Access Compliance Report

Public Rights-of-Way

(Curb Ramps)

Intersection ID: 42727	Main Street: SPEEDWELL_CT	Cross Street: PICKEREL_LN	Location: E
ADA ID: 8C4D7D6F97B5	Ramp Type: Perp	Initial Pass/Fail: Fail	Overall Compliance: No
Codes/Mitigation Info/Possible Solution		Field Measurements/Component Compliance	
Severity Score: 13.75

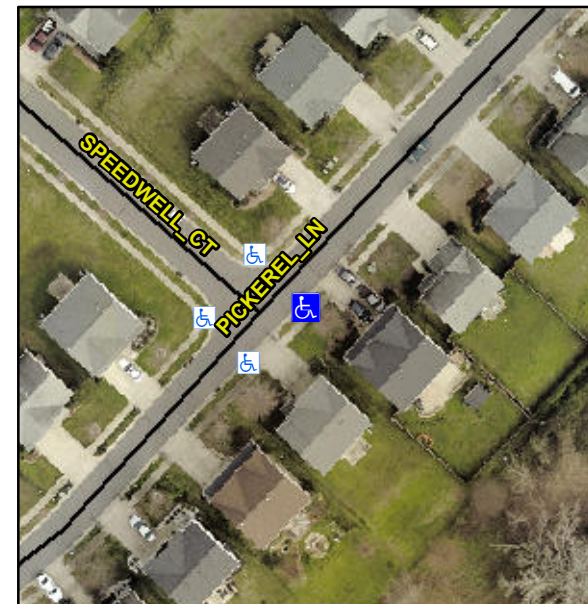
Not Found, R304.2.2, R304.5.3

Compliance	Description	Data	Compliance	Description	Data
N/A	Ramp Length (in)	48.0	No	Ramp Slope (%)	8.5
Yes	Ramp Width (in)	49.0	No	Ramp XSlope (%)	2.8
N/A	Flare Type LT	N/A	N/A	Flare Type RT	N/A
N/A	Flare Slope LT (%)	N/A	N/A	Flare Slope RT (%)	N/A
N/A	Flare Traversable LT?	N/A	N/A	Flare Traversable RT?	N/A
N/A	Landing Length (in)	N/A	N/A	DWS Provided?	N/A
N/A	Landing Width (in)	N/A	N/A	DWS Contrast?	N/A
N/A	Landing Slope (%)	N/A	N/A	DWS Length (in)	N/A
N/A	Landing X Slope (%)	N/A	N/A	DWS Full Width?	N/A
N/A	Landing Curb? (Y/N)	N/A	N/A	DWS Offset (in)	N/A
N/A	Shared Landing?	N/A			
N/A	Gutter Ponding?	N/A	N/A	Gutter Slope (%)	N/A
N/A	Gutter Lip Ht (in)	N/A	N/A	Gutter X Slope (%)	N/A
N/A	Painted X Walk1?	No	N/A	Painted X Walk2?	N/A
	X Walk 1 Direction	To NW		X Walk 2 Direction	N/A
N/A	X Walk 1 Width (in)	N/A	N/A	X Walk 2 Width (in)	N/A
	X Walk 1 Slope (%)	5.6		X Walk 2 Slope (%)	N/A
	X Walk 1 X Slope (%)	1.4		X Walk 2 X Slope (%)	N/A

Remove & Replace Entire Ramp.
